STAFF REPORT: 12/13/2023 REGULAR MEETING

APPLICATION NUMBER: HDC2023-00046

ADDRESS: 4750 CORTLAND

SCOPE: REPLACE WOOD WINDOWS

Site Photo 5, by Applicant 2023: (South) front elevation, showing proposed replacement locations of windows 1-8.

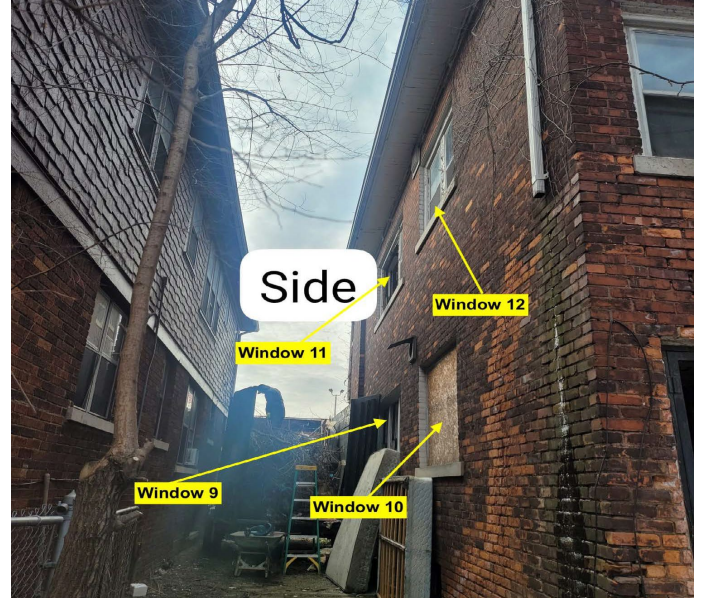
The applicant proposes to remove wood boards on window openings, remove wood windows, and install new windows at 12 locations as shown in the attached window schedule. Staff requested verification of the remaining windows that were replaced but did not receive an update from the applicant at the time of this report. Therefore, this application does not address the remaining vinyl windows that are shown in the applicant’s window schedule. An earlier version of the application which showed that the proposed windows were to be Jeld-Wen vinyl windows has since been replaced with Anderson wood windows. However, staff has not received product information that shows the design details of these windows at the time of this report. All installed windows are proposed to have white trim and simulated divided light, but the configuration of these windows is not known.

- While the proposal to install wood windows is appropriate, the replacement of double-hung windows with single-hung or fixed windows would introduce a new design and operation that substantially detracts from and alters the historic appearance of the building. Furthermore, without understanding the full design, dimensions of the window's cross-sections, configuration of the divided light, placement in the window openings and dimensions for the new brick moulds, staff has incomplete information as to how the proposed windows will be framed in the openings, and therefore be potentially inconsistent with the general characteristics of the historic windows.

- Work was completed without the Commission's approval.
- No documentation establishing that the original wood windows were beyond repair was submitted or available.
- It is staff's opinion that the removal of the original windows and proposed replacement with single-hung, wood windows with unknown product information, configuration, design and dimension detailing will greatly alter the original *scale, design, and materiality* and introduces new materials that are incompatible and inappropriate for this historic property, and therefore does not meet the Secretary of the Interior's Standards for Rehabilitation.
- Staff has not received any brick mould or cross section details of the proposed windows, nor repair of damaged or missing window sills or headers. Staff believes these are necessary details to demonstrate that the proposal is compatible and historically appropriate.

Staff therefore recommends that the Commission issue a Denial for the proposed window replacement, as it does not the Russell Woods-Sullivan Elements of Design nor meet the Secretary of the Interior's Standards for Rehabilitation, specifically Standards:
